# PERMIT

## SEWAGE DISPOSAL SYSTEM

#### HOWARD COUNTY HEALTH DEPARTMENT

REPAIR - PURPOSE - DRAINFIELDS ARE FAILING.

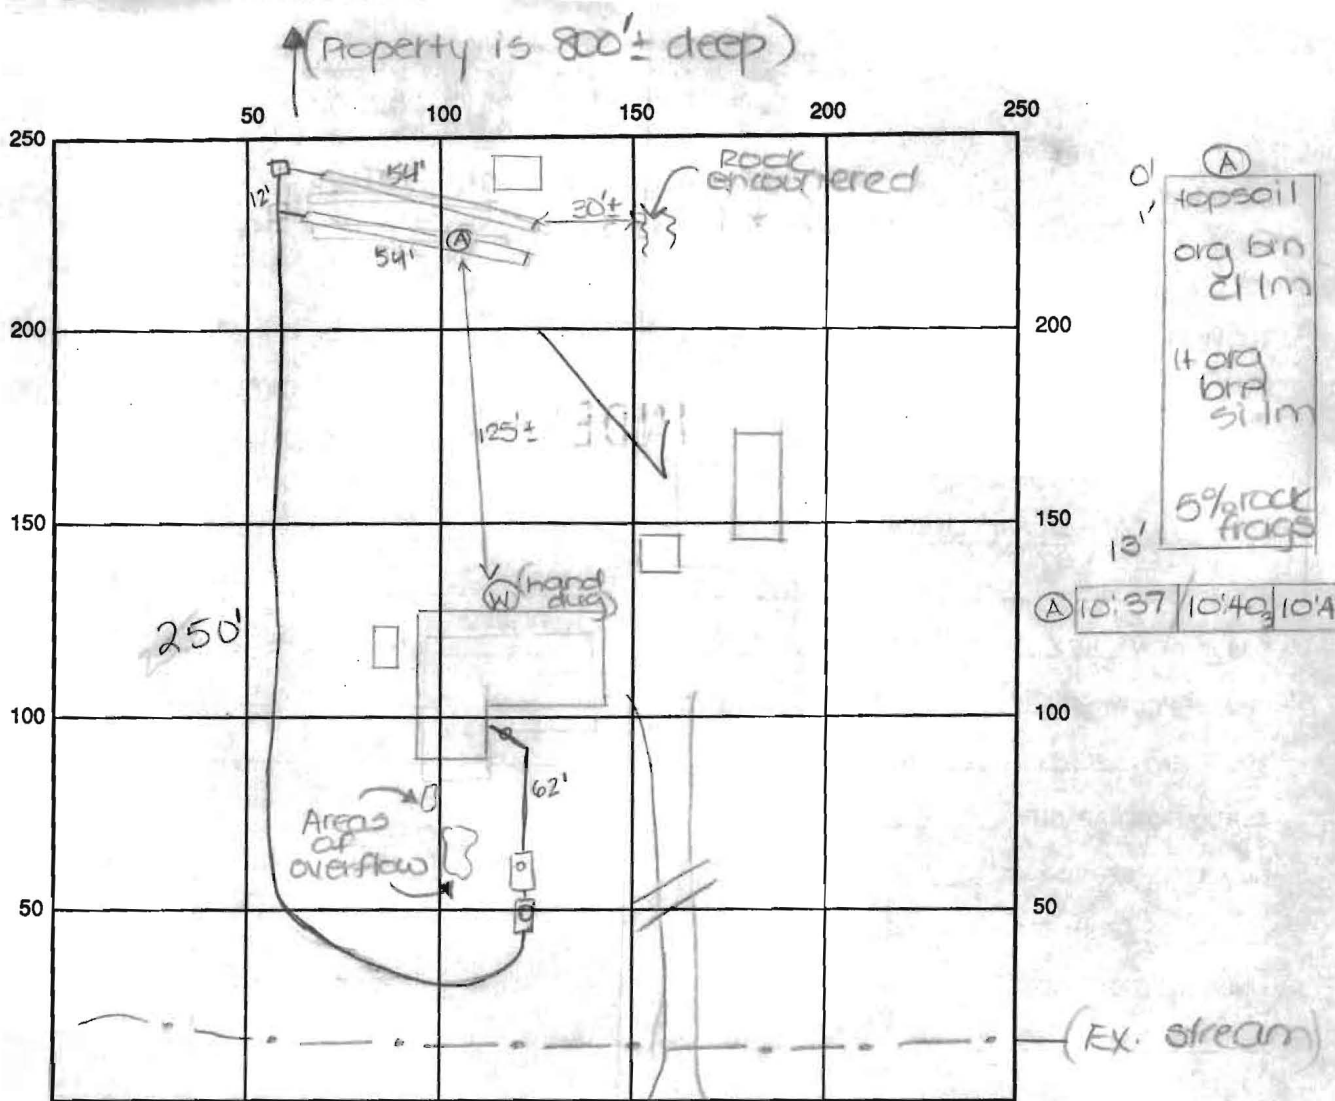
REMARKS: 3/25/97 perc hole (A) OK. Specs given to contractor.

[Homeowner at site - hand dug well to be replaced in the near future] DKS

4/3/97 rock encountered as indicated. Contractor to install 2-54' trenches through perc hole (A). OK to continue. DKS

4/4/97 OK to cover trenches and continue. DKS

4/7/97 OK to cover all work KM

Install new top seamed s.t. and pump pit 100'+ off  
existing hand dug well. Pump up to area of perc hole.  
Install trench(es) at perc hole on contour.  
Trench(es) to be 2' wide, inlet 4.5', bottom 9.5', stone 5'.
